AMENDMENT NUMBER THREE TO THE LANDFILL OPERATIONS SERVICE AGREEMENT

WHEREAS, PCSW staff proposes to relieve traffic congestion going to WTE Facility by providing a Tip Trailer Transfer Area on the PCSW Disposal Complex for tip trailers customers to dump their loads.

Figure 1 – Site Location and Proposed Site Layout and Drainage

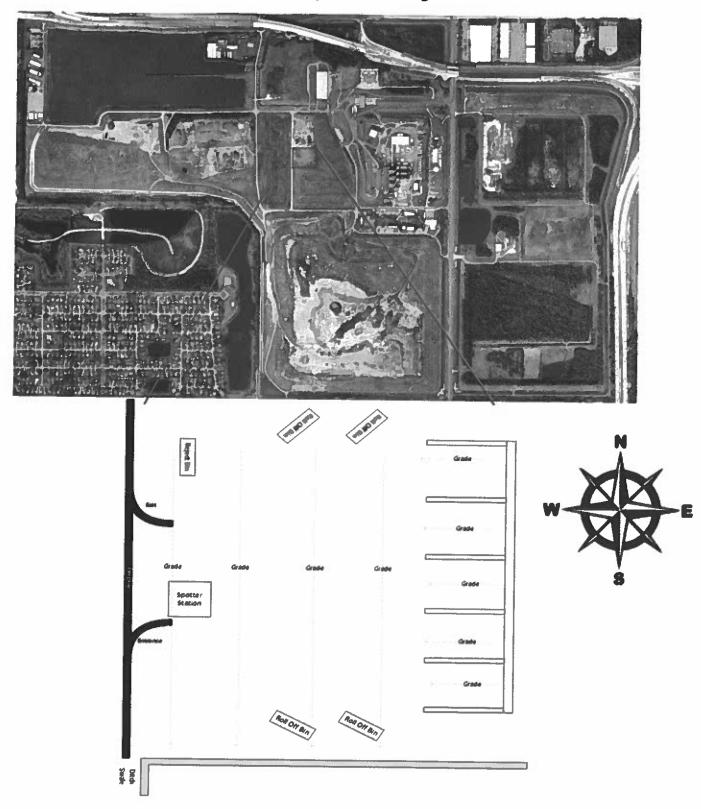
- B. The Tip Trailer Transfer Area will be located approximately around the southern portion of the west side of Cell 2 of the PCSW Disposal Complex, as shown on Figure 1 attached hereto.

- D. The Contractor will be responsible for grading the site area to prepare for construction of the Tip Trailer Transfer Area. Grading will consist of pushing excess dirt, existing base material, and minor vegetation to the east portion of the Tip Trailer Transfer Area to be used as a berm to support the push wall. Grading will be accomplished to route the Tip Trailer Transfer Area stormwater runoff to the existing ditch swale on the south side of the Tip Trailer Transfer Area as generally depicted on Figure 1. The existing ditch swale will be cleaned of vegetation as part of construction and made large enough to accommodate the expected stormwater runoff.

- E. Base material used to construct the surface of the Tip Trailer Transfer Area shall be processed <3/8" ash generated from the WTE Facility and compacted. Grading of the operating surface shall provide surface water runoff to the south. Like operations thereof, the Tip Trailer Transfer Area construction must be consistent with any permits imposed by regulatory agencies involving the PCSW Disposal Complex.</p>

- F. The Contractor will provide at least four (4) clearly marked and delineated lanes for customer unloading in the Tip Trailer Transfer Area. The Contractor will construct sufficient tip bays to appropriately accommodate vehicle volume.
